Building Permit Application

Permit No.: B17002743

RE: B17002743
14051 Tall Ships Drive
West friendship, MD 21794

This letter is in response to building permit **B17002743**. The application describes SFD/ 1-STORY ADDITION - MASTER BEDROOM & BATH ON FIRST FLOOR/ APPROX - 35X24. Since a living space addition is being proposed on a property with a private well & private sewage disposal system, this triggers the requirement to evaluate the existing septic record and the adequacy of both well and septic system components.

BETH HUBBARD
14051 TALLS SHIP DRIVE
HOWARD COUNTY PERMIT #B17002743
1" = 60 FEET

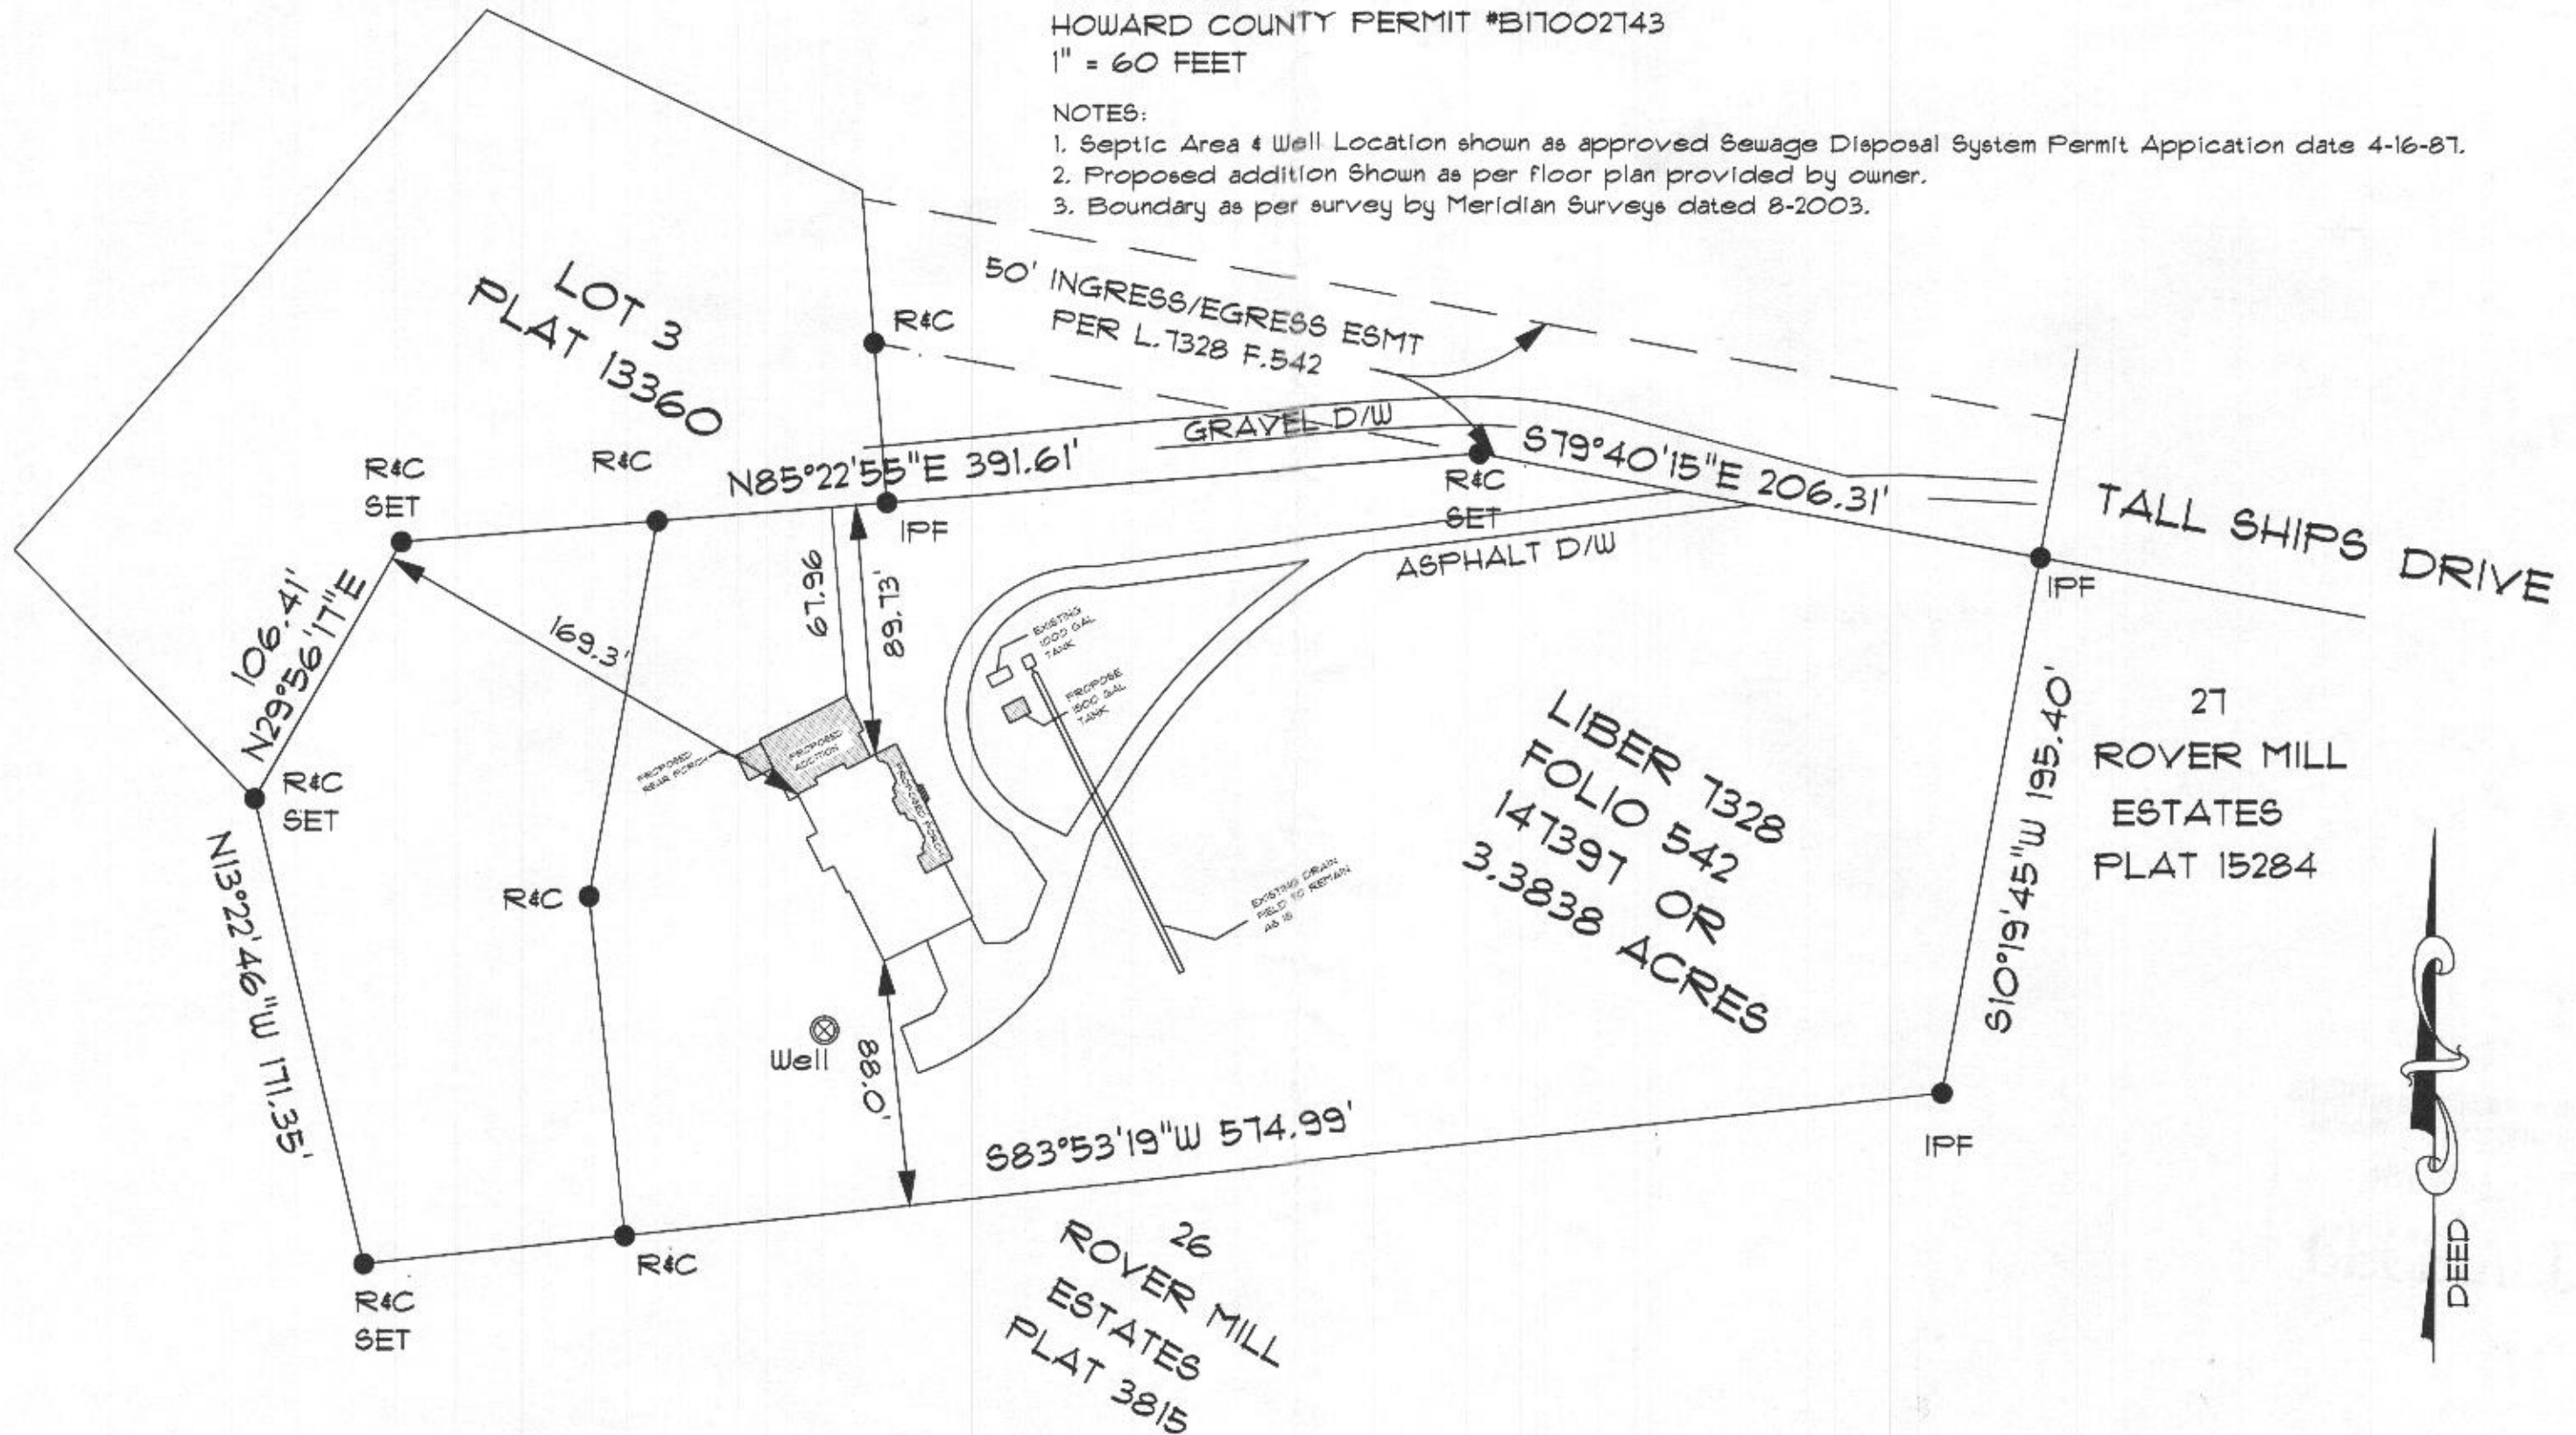
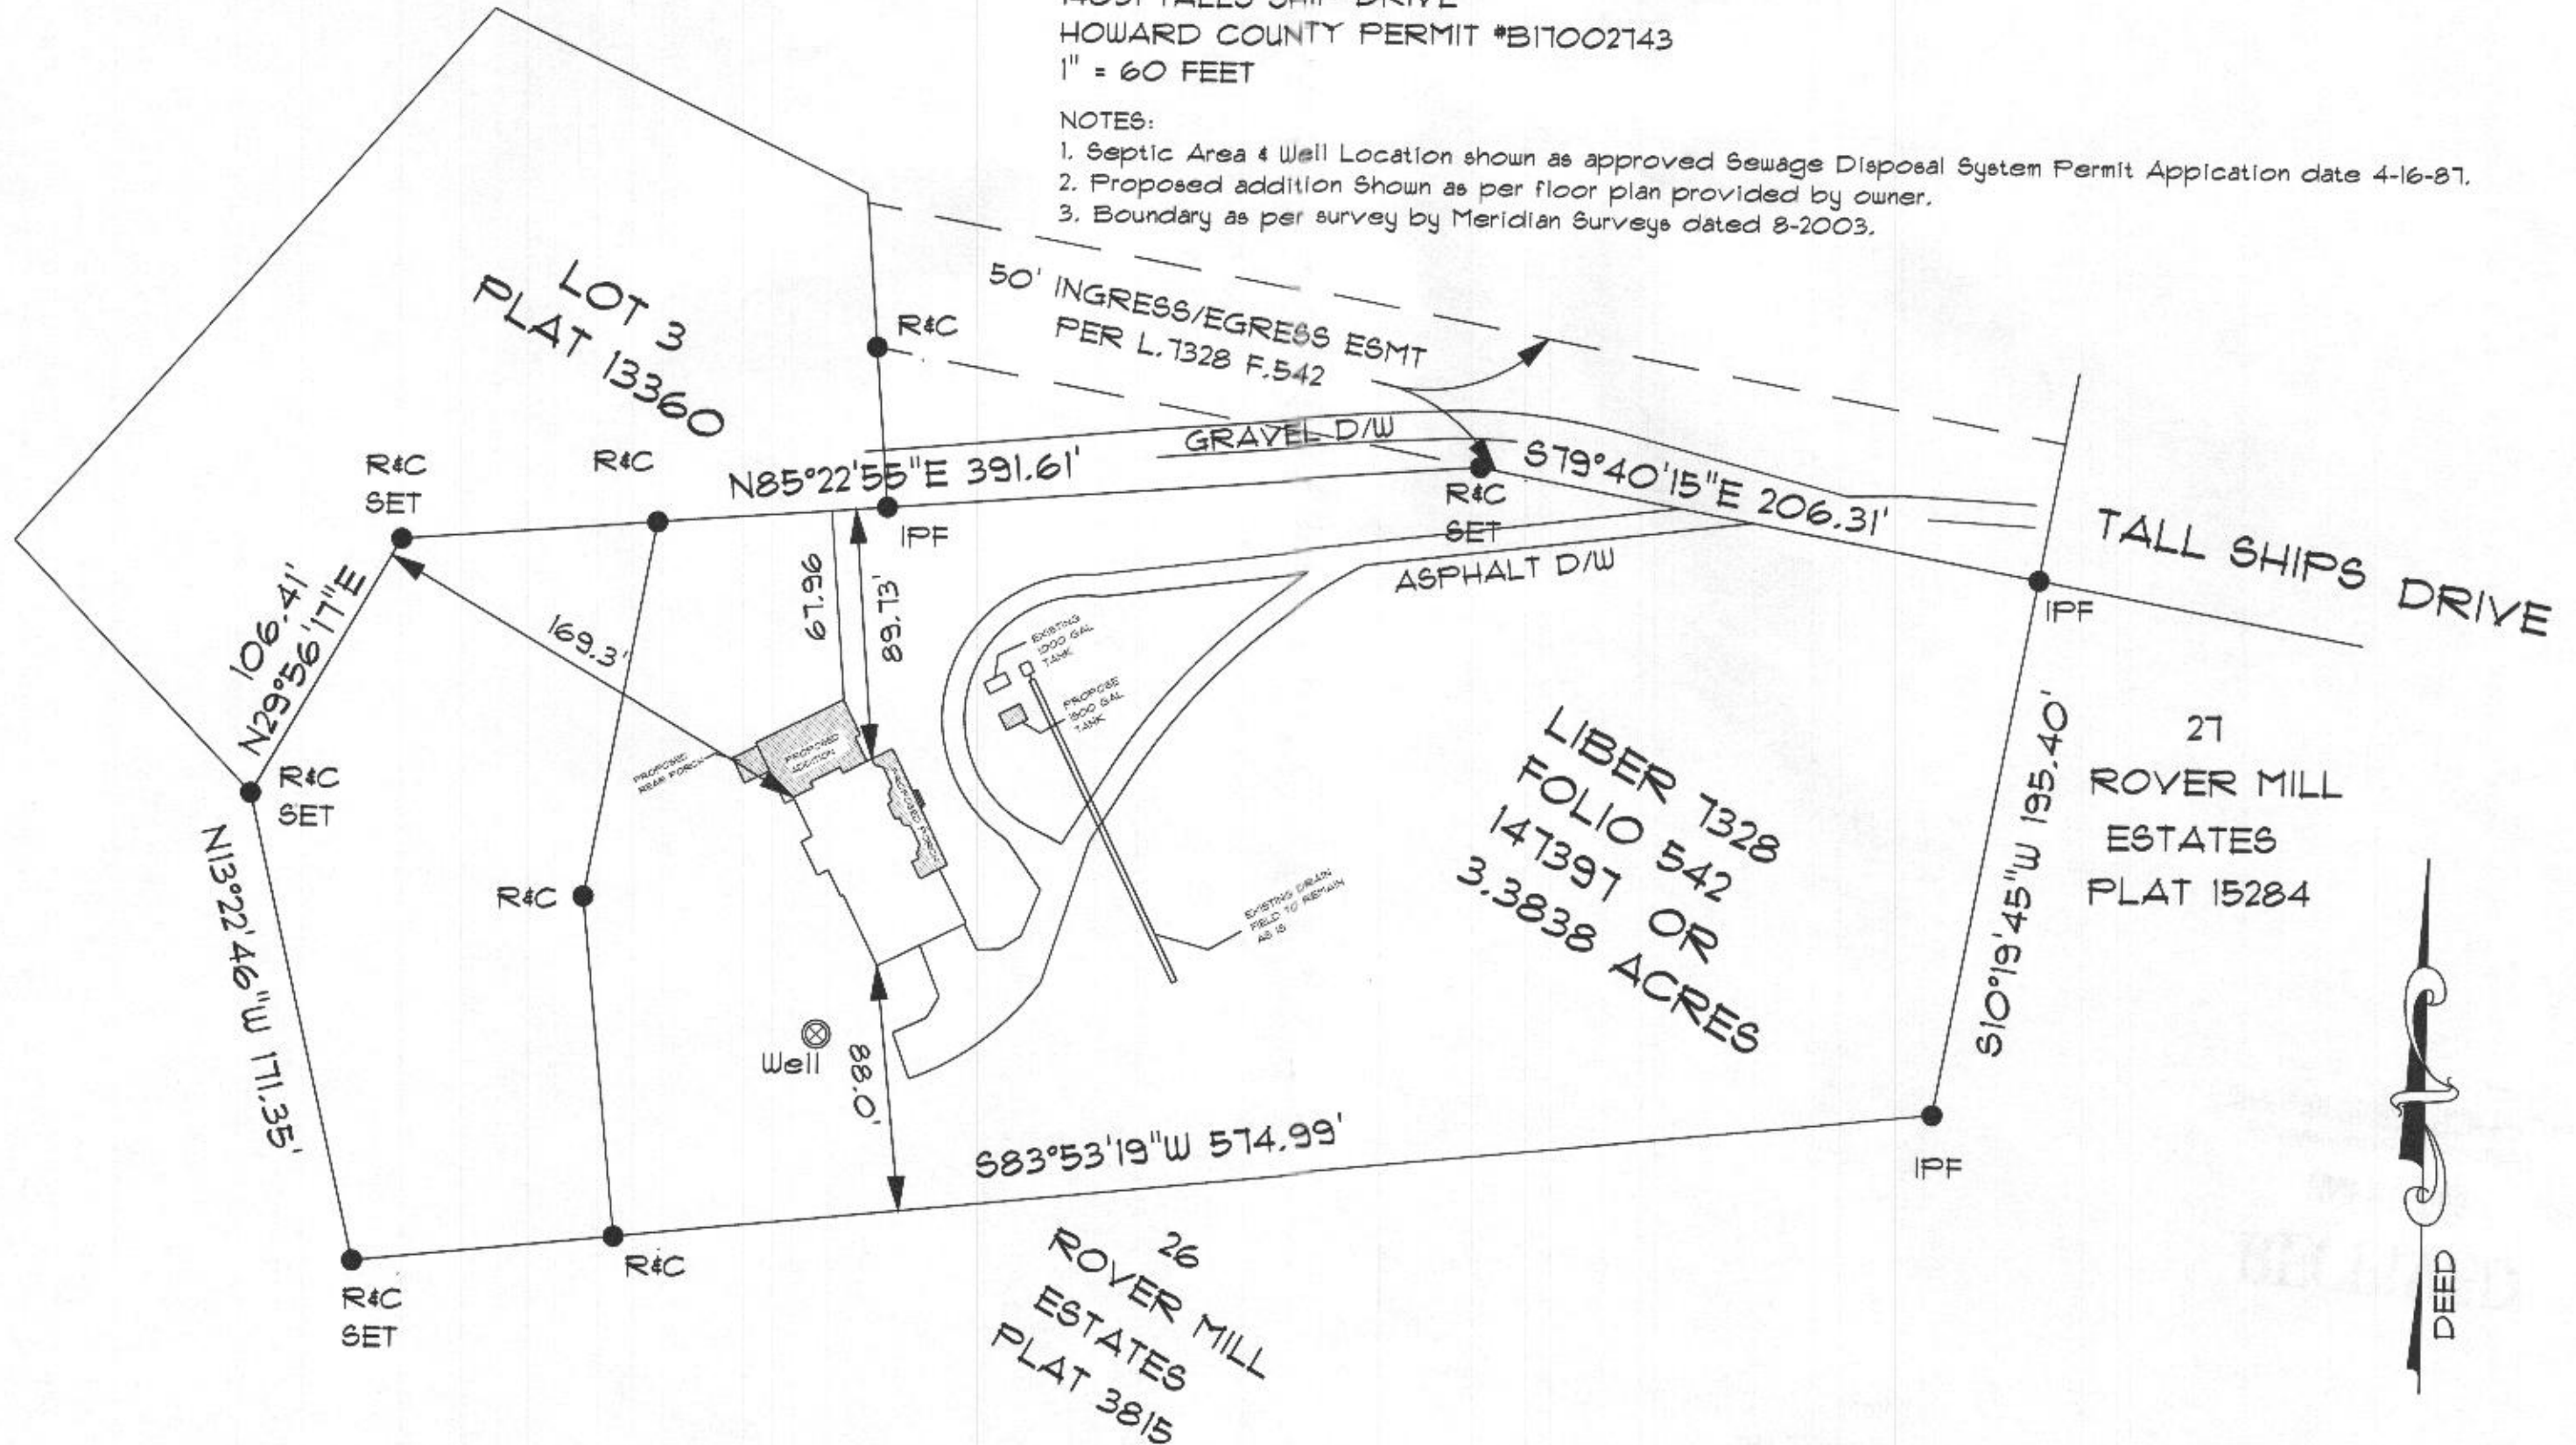
In addition to the floor plans, please revise site plan to show all septic system components per As-Built drawing i.e. septic trench (See attachment). Also show to alternate well sites meeting the well & septic setback requirements (See attachment). Building permit approval has been placed on hold until floor plans (for the existing house plus proposed addition), a revised site plan and any necessary upgrades have been approved by the Health Department.

Thanks for updated plan. In speaking with my supervisor about this plan, a concern was raised about the portion of the existing trench underneath the driveway. According to our records, we didn't approve this when the system was installed. Looking ahead, we will need to confirmation from the septic contractor that the pipe within the trench has not been crushed/compromised.

At the time of new tank installation, the septic contractor will need to camera the line to confirm this by way of the d-box. Also, we will need to confirm that the pipe is scheduled 40 pvc. If it isn't scheduled 40 pvc then it will need to be replaced. Also, if the portion of the driveway over the trench isn't paved, it will need to be paved or abandoned. A gravel driveway tends to get ruts and collect water in addition to poor load disbursement unlike a paved driveway.

Thanks for the clarification on the floor plans. The proposed office does not meet the minimum dimensions so it won't be considered a bedroom. However, you are still increasing bedrooms from 3 to 4 so the septic tank will need to be upgraded prior to BP approval. In addition, the building permit site plan will need to be revised because it does not match the As Built drawing (i.e. well locations are different and it does not include the septic system components (i.e. septic tank and trenches) or the proposed concrete porch.

At the time of new tank installation and abandonment of the old tank, please have the septic contractor expose the d-box to verify the pvc rating and camera the line to prove that it is still intact underneath the driveway.

Please revise the BP site plan and have a septic contractor apply for a septic permit to upgrade the septic tank (most likely a 1500 gallon, 2 compartment tank). When you revise the building permit site plan, please add the proposed septic tank location to the plan meeting setbacks.
